## PLANNING COMMISSION MEETING STAFF REPORT

**NAME OF PROJECT:** Huntleigh Woods

**AGENDA ITEM:** Preliminary Approval

**Subject: Huntleigh Woods Preliminary Approval**

**CS-100**

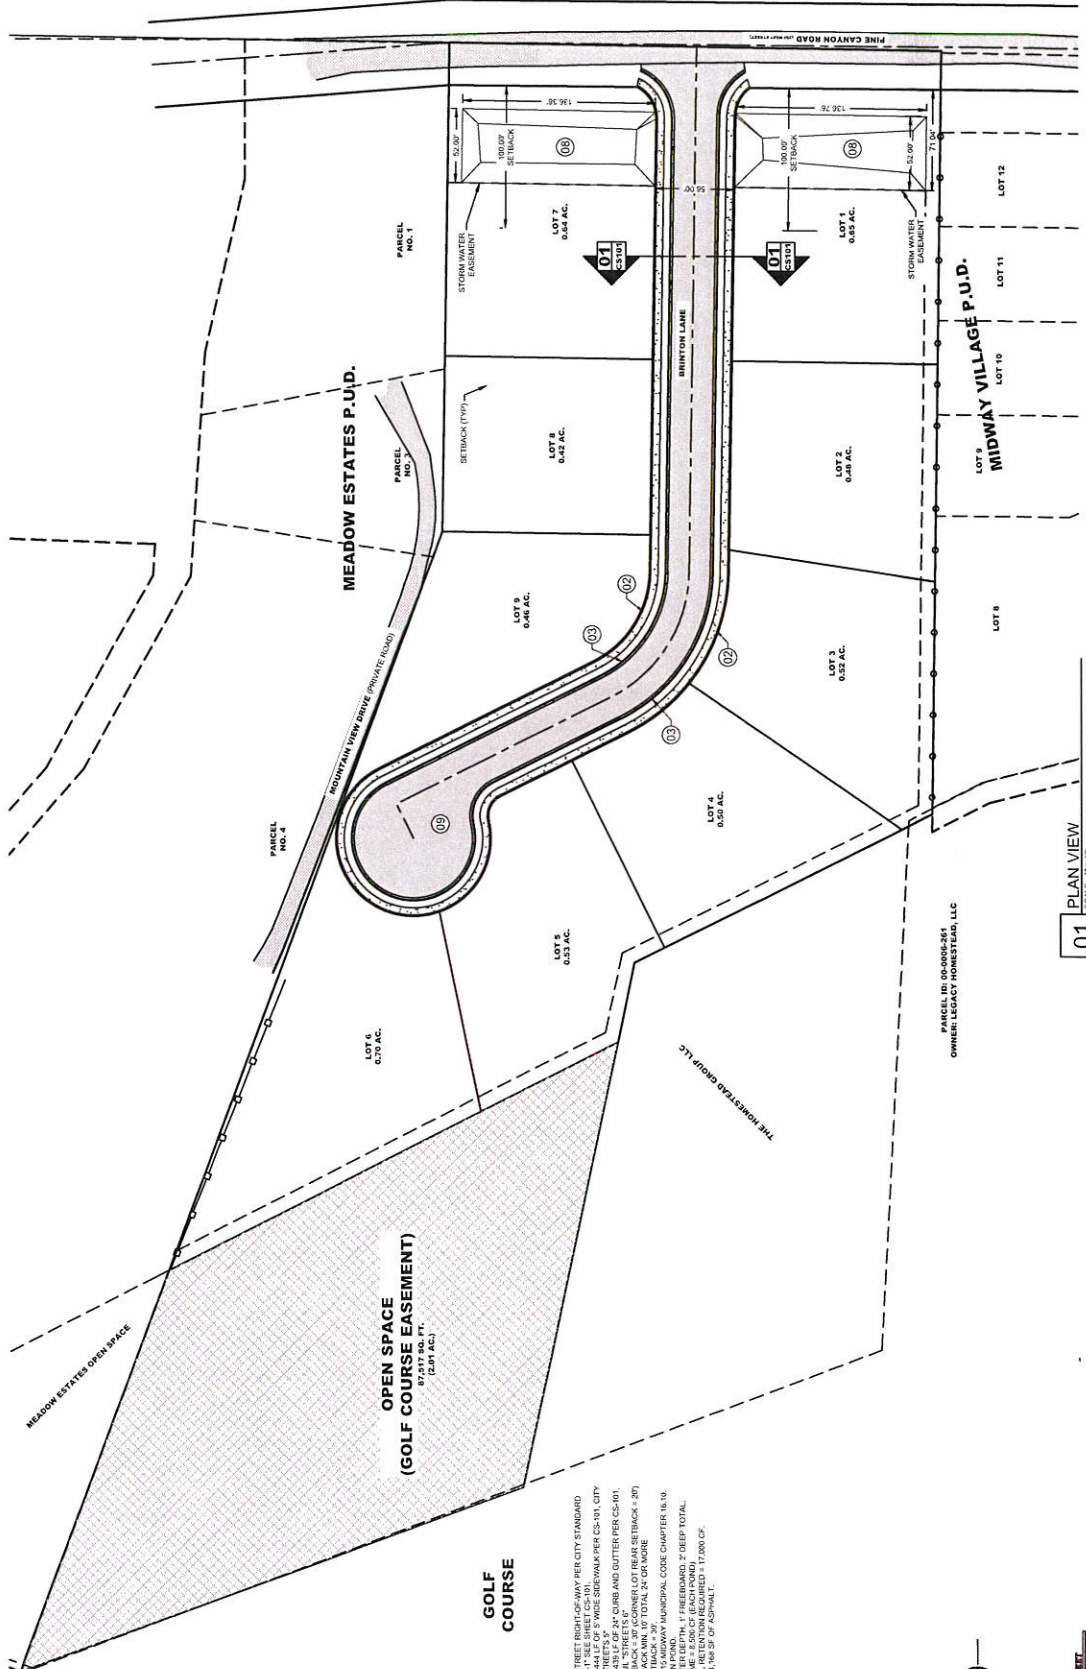
- The plans propose to develop 9 lots on approximately 8.10 acres near 700 North Pine Canyon Road.
- All redline comments within the preliminary plans should be addressed.
- A geotechnical report will need to be submitted.

- The proposed development will be served from the Gerber Mahogany Springs zone.
- The proposed development will connect to the existing 10" water line in Pine Canyon Road.
- The fire hydrant spacing shall not exceed 500'.
- Existing 12" transite water line that runs through the proposed subdivision will need to be removed and the Homestead maintenance shed water lateral be re-established.

- The proposed development will connect to existing irrigation in Pine Canyon Road and will need to install services with meters according to Midway Irrigation Company standards.

- The proposed road within the development will be a 56' public right-of-way, with a cul-de-sac at the west end of the development.
- Cross section for right-of-way will be 30' of asphalt, 2' curb and gutter, 6' park strip, and 5' sidewalk.

- The proposed development will connect onto Midway Villages trail to the south and will end at the north end of the development.

- The storm water system within this development will be a public system. The storm water will be addressed through the use of sumps and retention basins.
